**City of Florence
Planning Commission Meeting Minutes
250 Hwy 101, Florence, OR 97439
August 23, 2022**

4. RESOLUTION PC 22 05 DR 04 & SR 22 11 SIR 06 – Quince Street Wyndham Microtel Design Review and Phase 1 Site Investigation Report

**PC 22 05 DR 04 & AR 22
11 SIR 06**

Site Plan

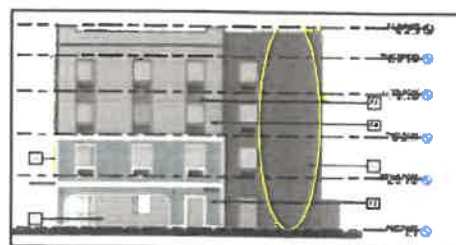
Comm Murphey asked that on decision point #6 to permit off street parking between the building and the street, we have talked about the pedestrian walk way to the front entrance into the hotel, if we allow this parking West of the hotel it looks like it is free range parking once you get out of your car, are you just walking in the parking lot, do we have sidewalks to get to the pedestrian crossing to the entrance and are we going to have ADA parking out in the West parking lot, that you want PC to approve?

Hearley showed parking lot site plan and explained that there are 3 pedestrian crosswalks in the parking lot.

Comm Murphey explained that in the West parking lot between Quince and the Motel, are we to consider all the parking spaces out front, do you park your car and get out, just like when you walk into Safeway, is that ok with us.

6. Permit off-street parking to be located between the building and the street, assuming mitigation measures are approved by the Commission that include each of the following: pedestrian pathways from the street to the building, landscaped berms and professionally designed landscaping.

Hearley said that this is how it would operate unless the PC wanted to consider something else.

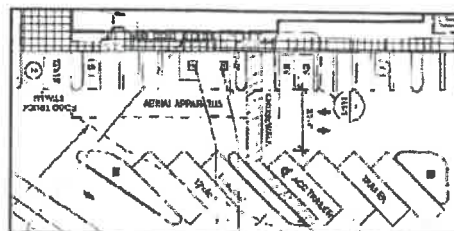
4.4. Per FCC 10-3-10 (H), the applicant's proposed bicycle parking plan shall demonstrate that such parking will not impede nor create any pedestrian hazards. Prior to issuance of final Certificate of Occupancy, applicant shall provide evidence to the Planning Department that the bicycle parking area will meet the requirements of FCC 10-3-10 (H).

4.4. continued. Plans provided did not give dimensions in the bike rack area for staff to determine if FCC 10-3-10 H was met. Revising the original proposed condition will ensure applicant will not need to go through an additional Design Review process.

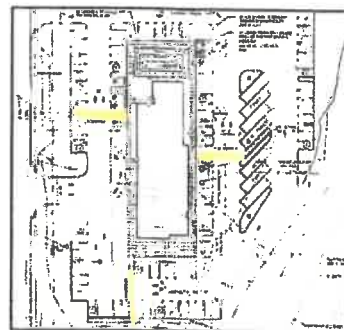
10.4. The applicant shall demonstrate adequate turn radius distances to the Fire Marshal under applicable Fire Code Standards, that fire apertures can safely access the site. Both Exhibit A (p. 76) & Resolution PC 22 05 DR 04 and AR 22 11 SIR 06 need to be amended to reflect changes to this condition.

10.6. Pedestrian crossings exceed distance requirements of 24'. Mark with contrasting materials unless Planning Commission approves proposal. Discussion point # 1 of AIS
